MEMORANDUM

To: Design Review Board
From: Aoife Blake, Associate Planner
Date: September 10, 2020
File No.: DRV20-00473
Subject: **MIRRA TOWNHOMES PROJECT
DESIGN RESPONSE CONFERENCE**

LIGHTING AND MATERIAL INTEREST

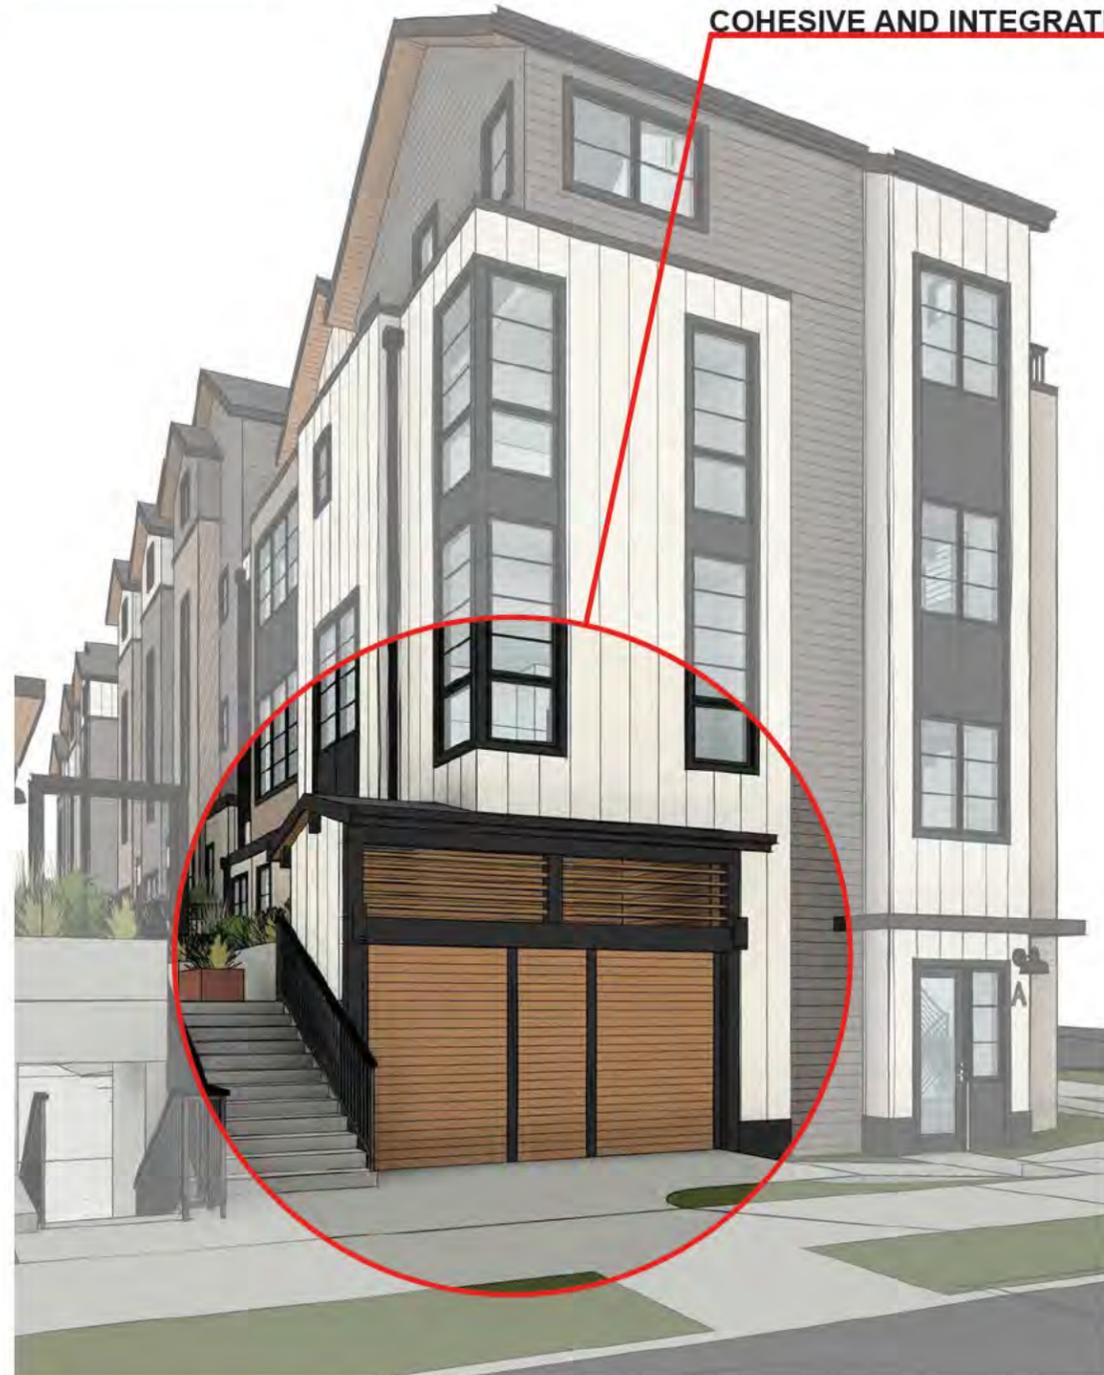
The proposed plans show the Public Works approved vehicular access from 2nd Street S (see Attachment 2). The appearance of the parking garage lid at the entrance is proposed to be softened by using an open railing and vertical plantings to create a roof-deck feel. Lighting is proposed along the driveway for security and wayfinding.

Four sconces have been added to the garage entrance to shed light, provide security and promote wayfinding.

The protective railing from the central pedestrian corridor has been reduced to a half wall of solid parapet with an open railing above. This adds levity to the entrance and a thinner profile for the deck floating above the entrance. These features are to make the driveway lid feel more like a roof deck above rather than an overbearing solid concrete plinth.

Steel planters are set adjacent to the railing which will add material interest to the entrance. Vertical plantings will add a softness and movement to the space. This also acts as a buffer for resident entries from vehicle headlights.

PROJECT DETAILS: Garbage Enclosure

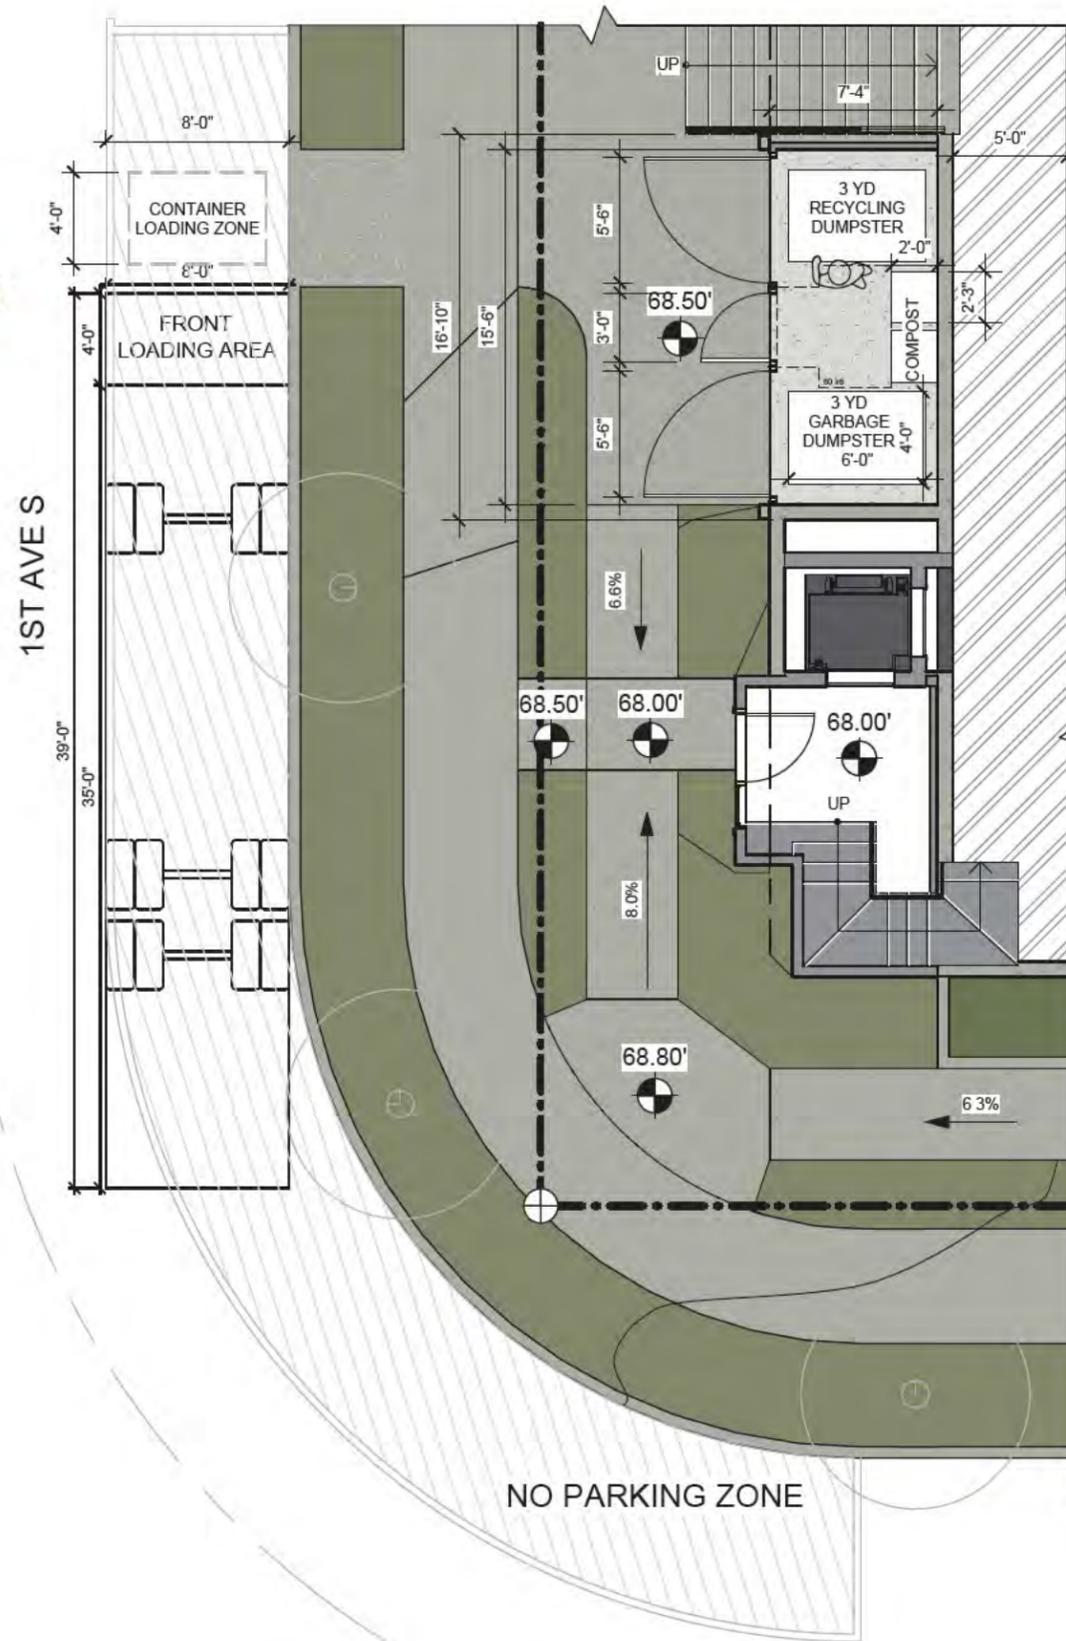
A garbage and recycling enclosure is located on the north façade of Building 1, accessed from 1st Avenue S. A trash pick-up layout has been provided by the applicant and approved by the City (see Attachment 2, sheet 12). The enclosure is screened with cedar clad steel doors.

SOLAR STUDY - Spring/Fall Equinox

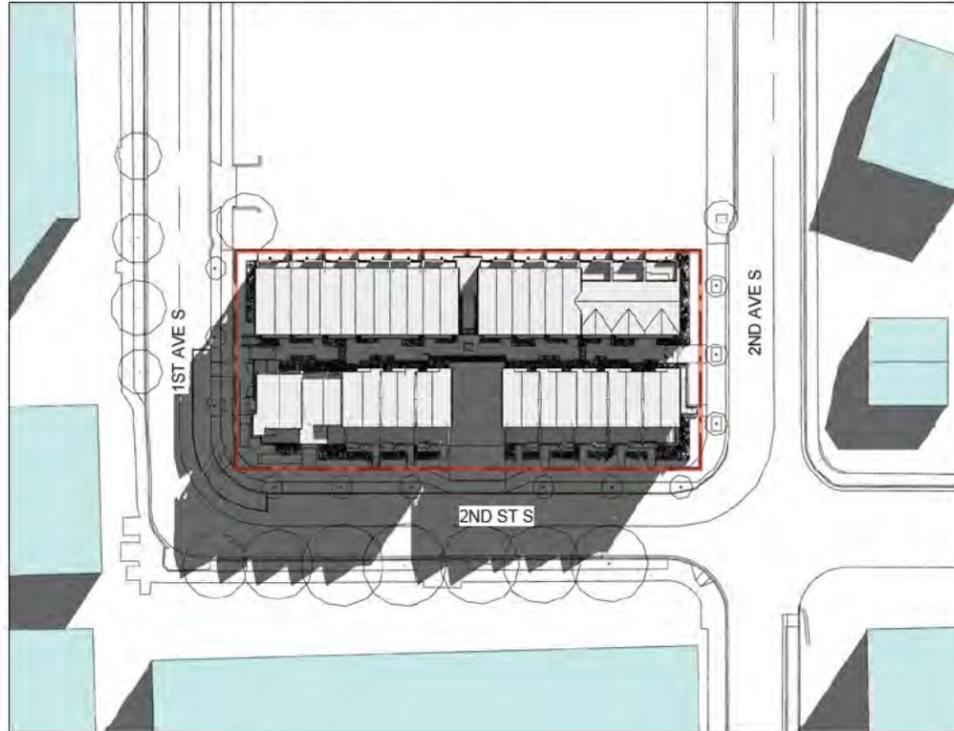
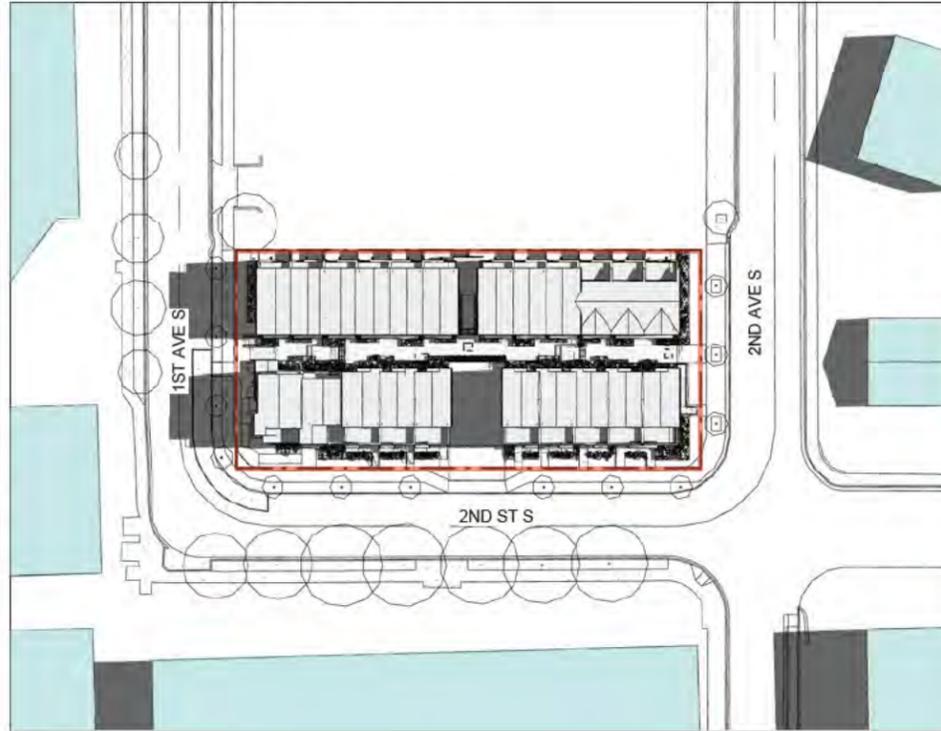
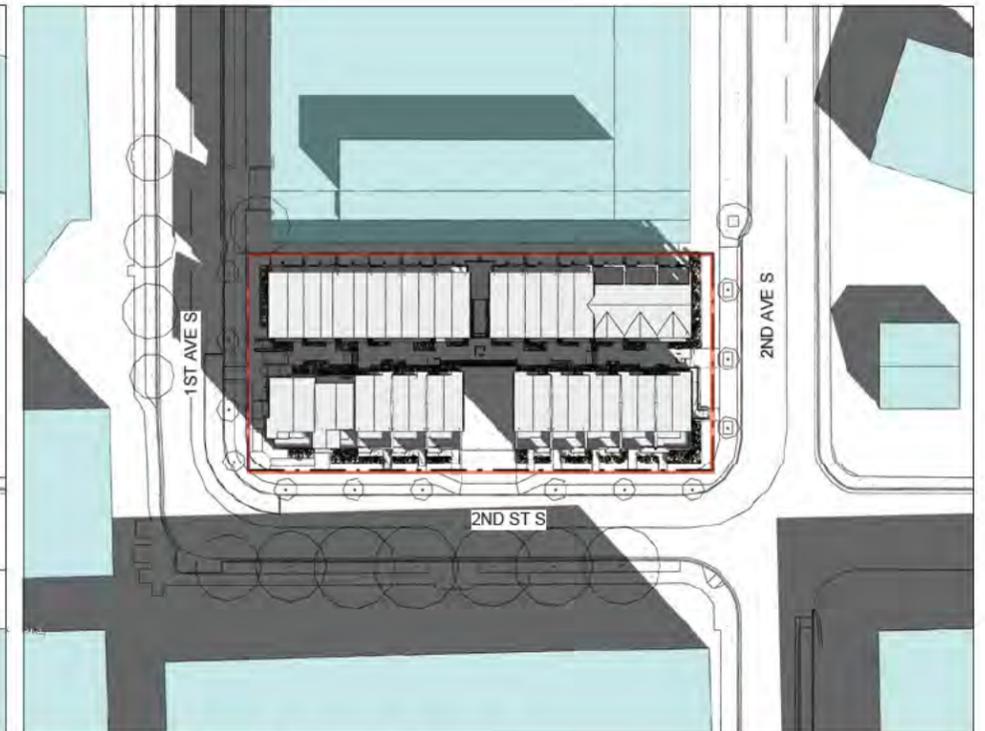
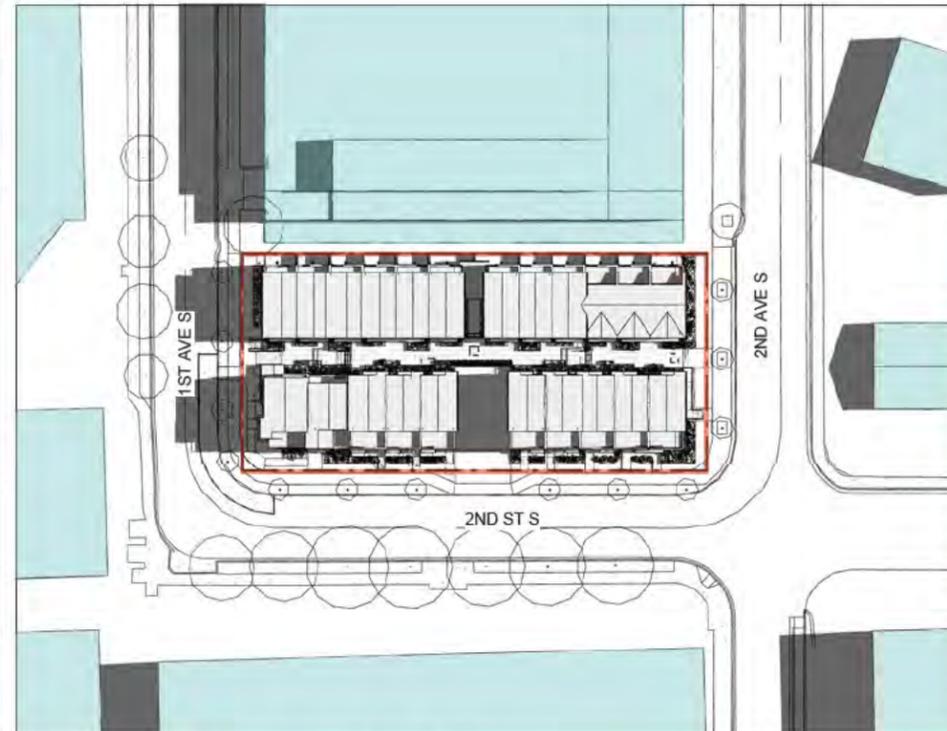
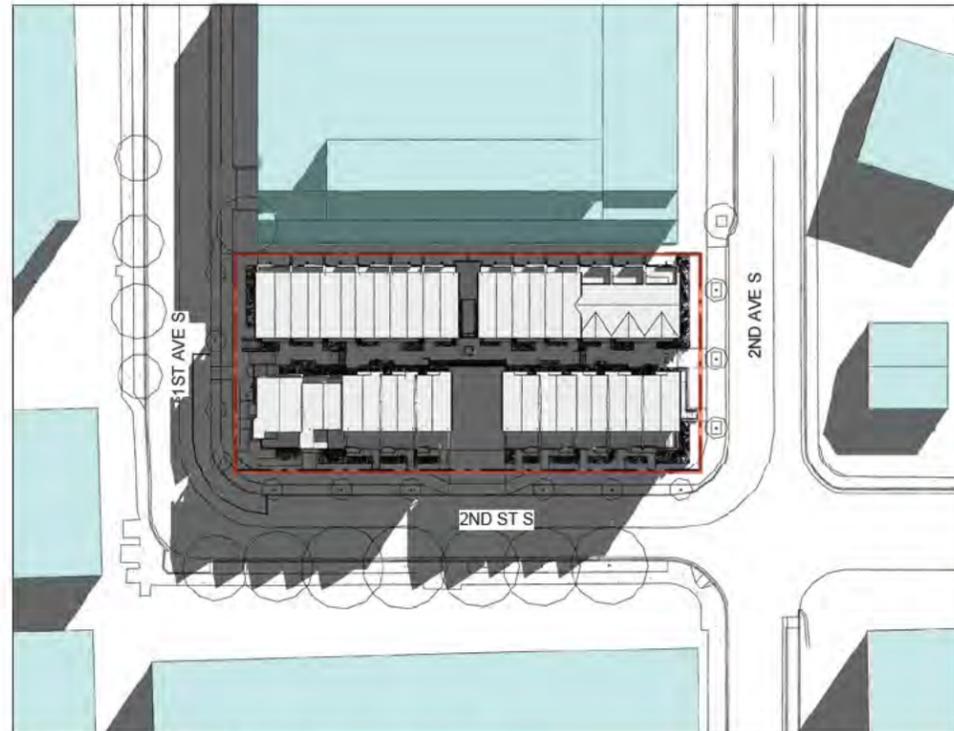
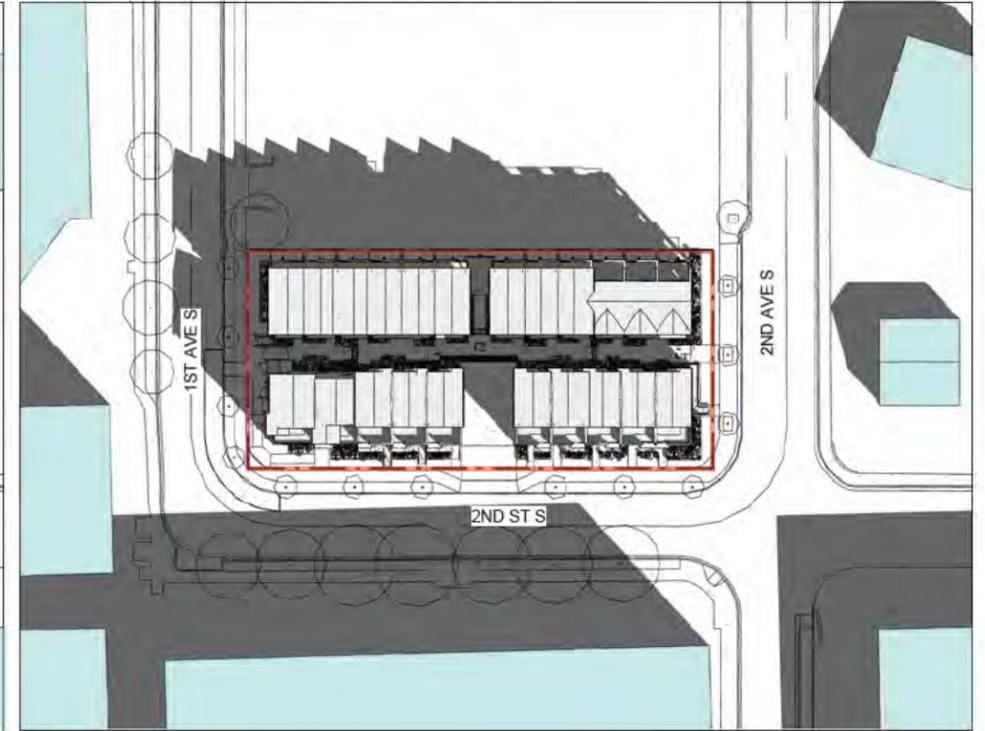
The applicant has provided a solar study (see Attachment 2, sheet 16) and a landscaping plan (see Attachment 2, sheets 17-18). The landscape plan shows the location of the proposed plantings and a plant schedule.

The DRB should provide input on the following items:

- *What changes, if any, are needed to the landscape plan?*
- *Are there other opportunities for landscaping?*
